Service information

Reference no.: SDA_92449

The coffee is dispensed drop by drop in Lavazza a Modo Mio

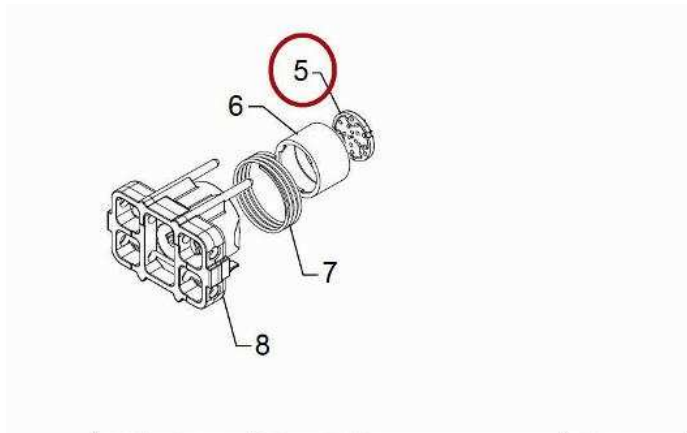
CURE:
To solve this issue, please follow these procedures:
Machines with serial number up to 9011sc10274241: if the drilling support (image 01 pos. 05) is "old", replace it with the new (image 02, old model is transparent color - new model is beige color) and, replace also the pump.
Machines with serial number from to 9011sc10274241: replace the pump.
